## **Inland Waterways Association – Evidence on Route Selection & Subsidence Risk in Cheshire**

### **HS2 Phase 2b - Working Draft Environmental Statement**

## **Rail Needs Assessment for The Midlands and The North**

Map Number	CT-10-307
Map Name	Environmental Baseline
Community Area MA02: Wimbodley to Lostock Gralam

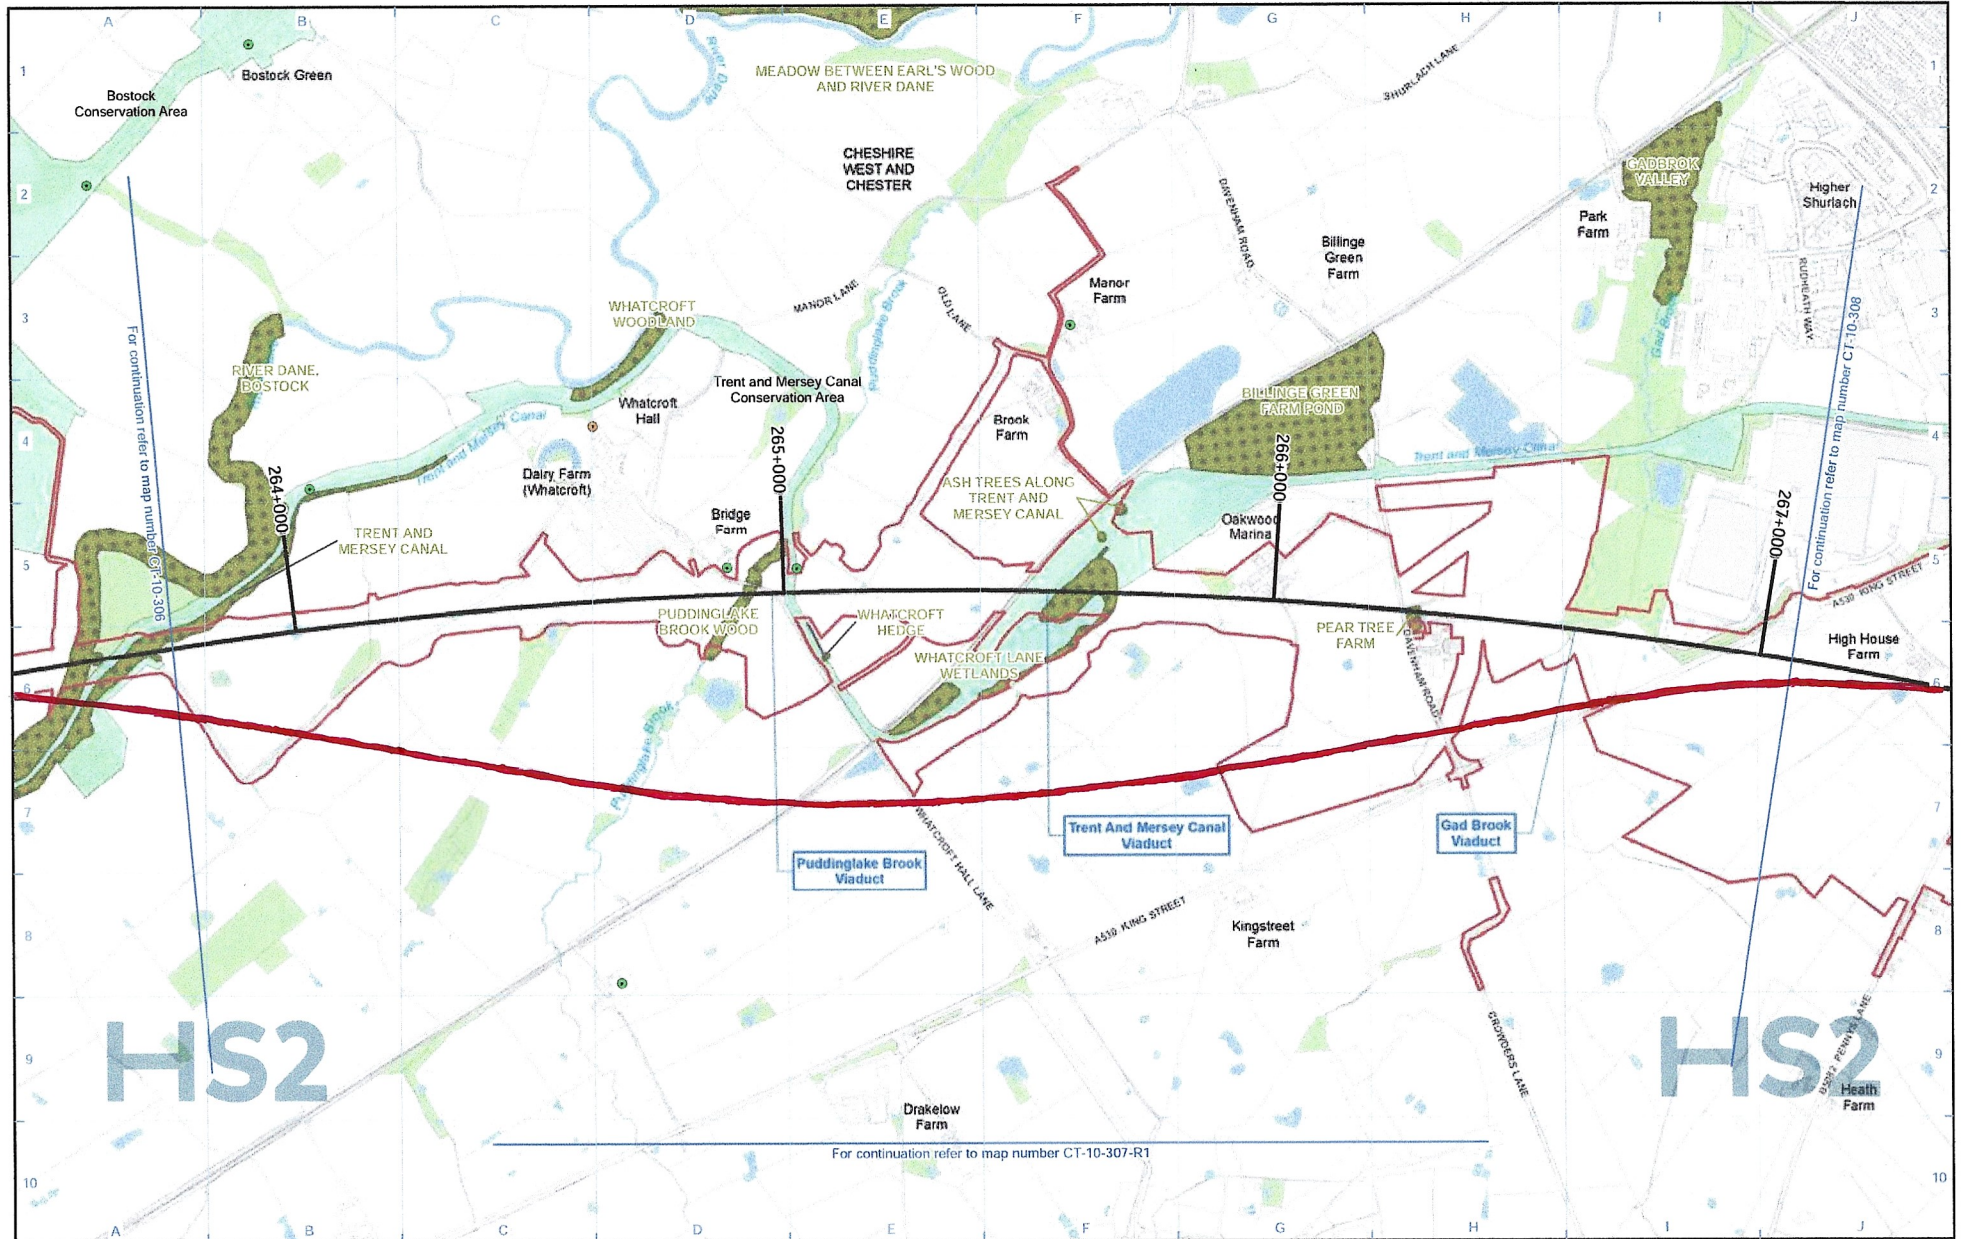
Given that the Billinge Flash area presents by far the greatest hazard to the construction, operation and safety of the railway, consideration should be given to a route modification that would avoid it. The Solid Geology map at Figure 3 of the Ground Risk paper shows that by moving the route to the east of Billinge Flashes towards the King Street Fault the length of the line crossing the Northwich Halite would be reduced. Figure 6 shows that this would then avoid all the major karst subsidence features.

Starting from the south, the River Dane viaduct would curve eastwards to cross the valley at a less acute angle, shortening the length of the viaduct and crossing the Trent & Mersey Canal further south. Continuing progressively further east of the Proposed Scheme across open ground it would cross the Puddinglake Brook further upstream and avoid both the Puddinglake Brook Viaduct crossing of the Trent & Mersey Canal and the Trent & Mersey Canal Viaduct at Billinge Flash. Bridges over the Sandbach-Northwich railway line and Whatcroft Lane would still be needed. The route would then curve back towards the west, passing east of Pear Tree Farm Cottages and converging on the Proposed Scheme around the King Street crossing.

For a sketch map of this proposal see IWA Alternative Route (drawn on CT-10-307 Environmental Baseline Plan)

This route modification would provide significant cost savings by shortening the River Dane Viaduct, removing the Trent & Mersey Canal Viaduct entirely, and avoiding expensive engineering work most likely to be needed around the uniquely hazardous Billinge Flash area. It would also greatly reduce the visual and noise impacts of both construction and operation on the heritage, wildlife and recreational corridor of Trent & Mersey Canal and its users.
